Item No. AD-1.4:                    Reference Deleted Sections

Item No. AD-1.11:                    Reference Revised Drawings

RESPONSES AND VARIOUS CLARIFICATIONS TO  
F13-13 INDIAN SPRINGS HIGH SCHOOL ATHLETIC COMPLEX

**INDIAN SPRINGS  
ATHLETIC COMPLEX**

Designed: DB/SW/MS Project No. 3137103106  
Drawn: BP/ AL Scale: AS NOTED  
QAQC: SW/ TH Drawing No. **A1.30**  
Date: 09/30/2014

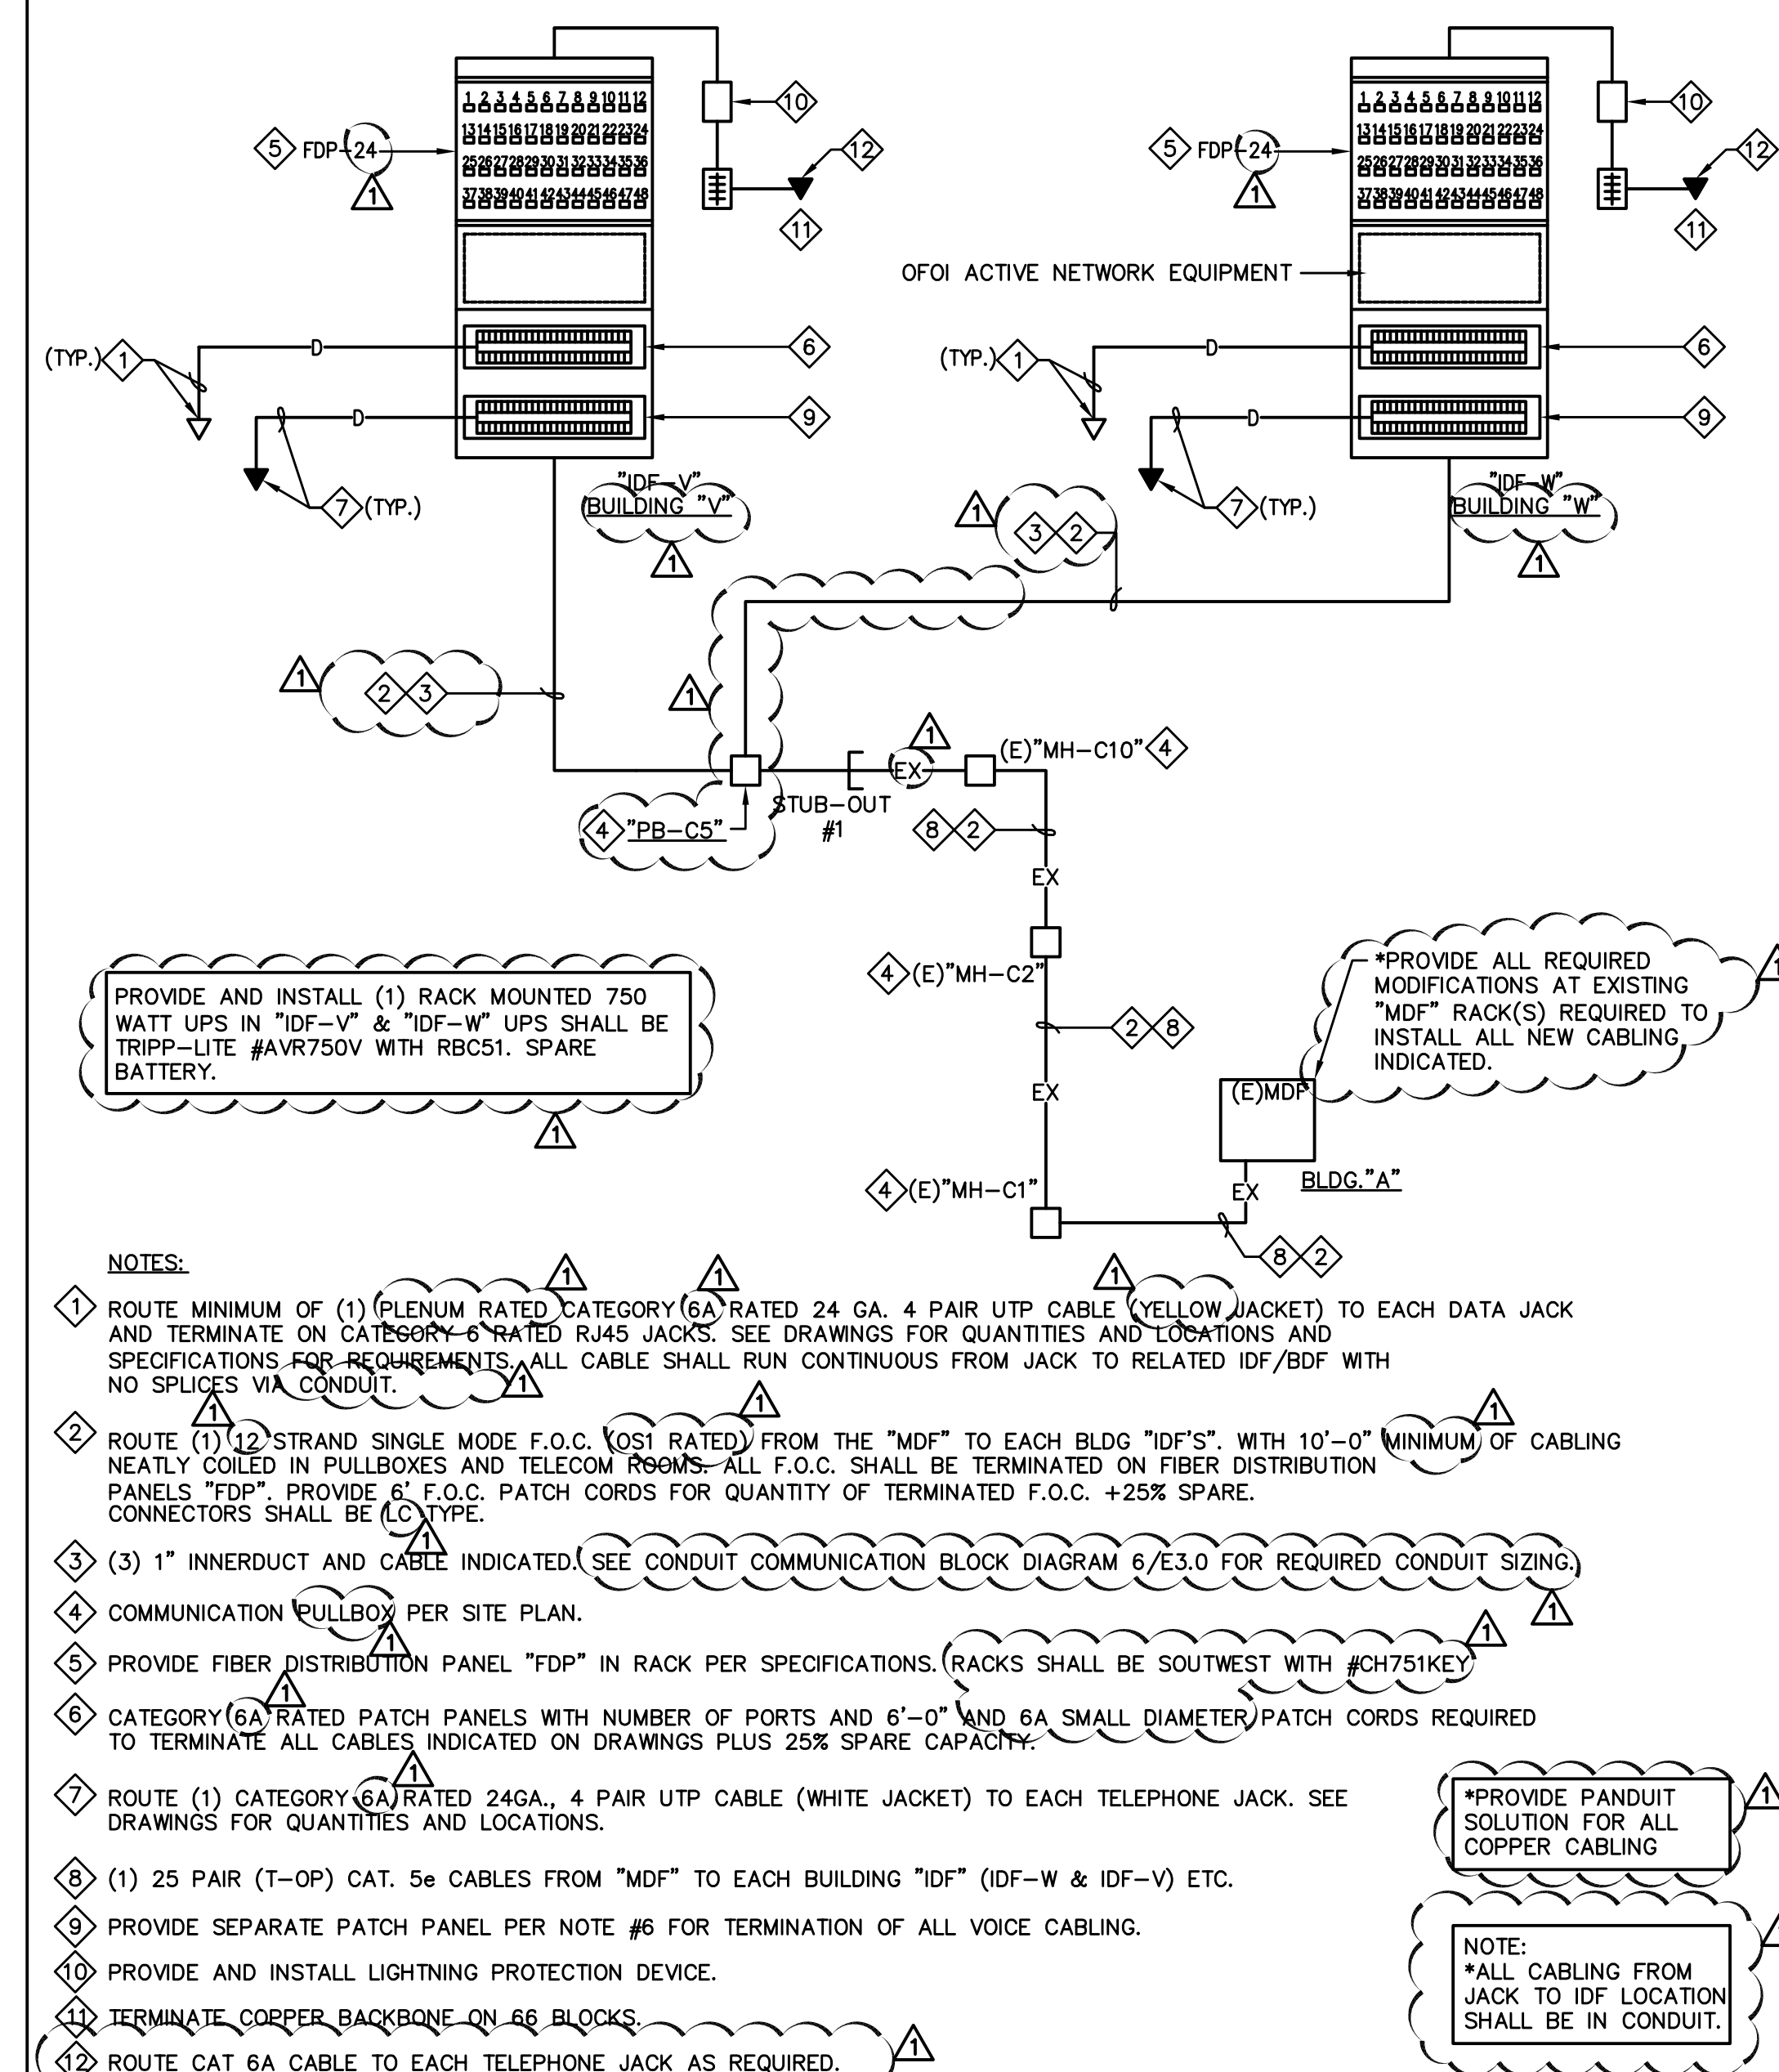
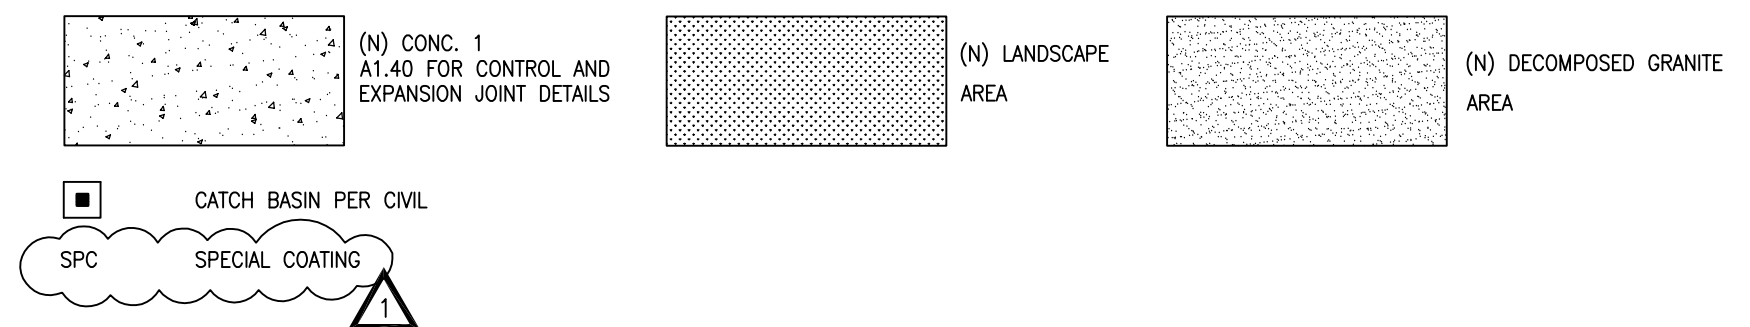
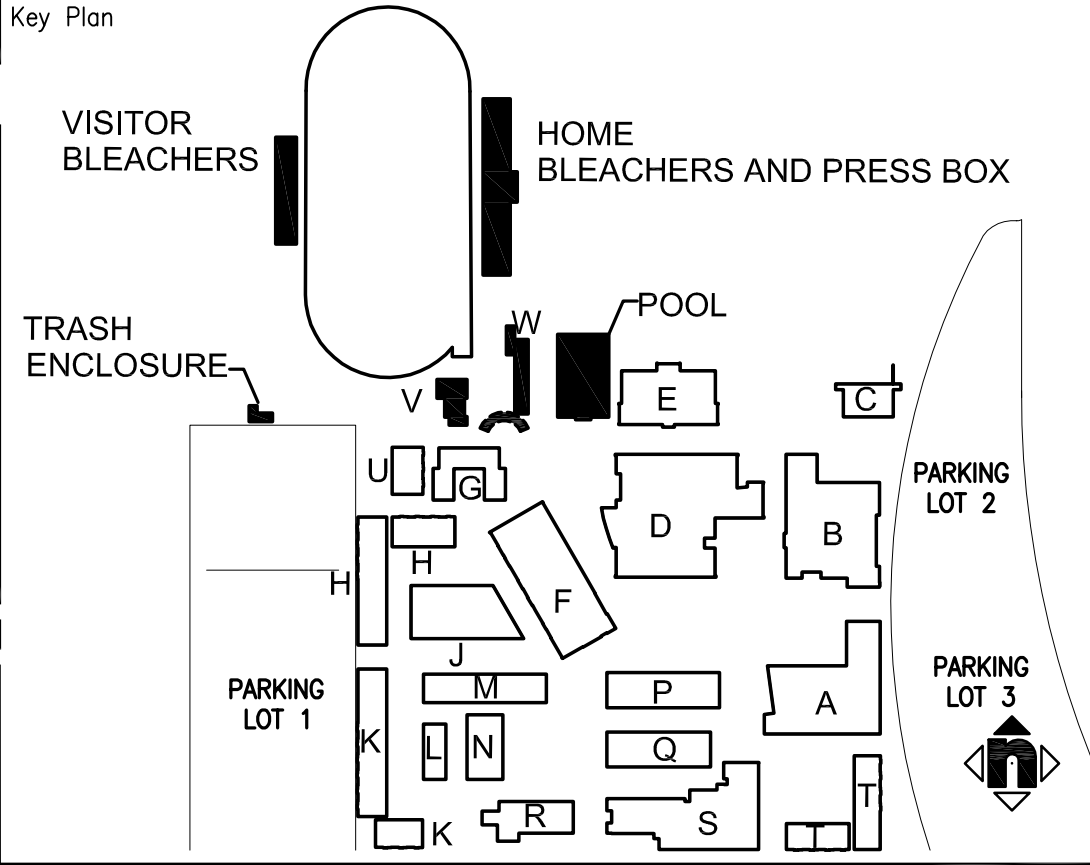
AD-1.01 (Reference A1.30)  
AD-1.02 (Reference E1.1, Electrical Site Plan)  
AD-1.03 (Reference E3.0, Communication Riser Diagrams)

Q2. Reference spec section 323119 Fences and Gates-Ornamental Metal- it states to field paint metal. Reference sheet A1.30 gate schedule it states finish is galvanized. What is finish?

A2. See attached Addendum
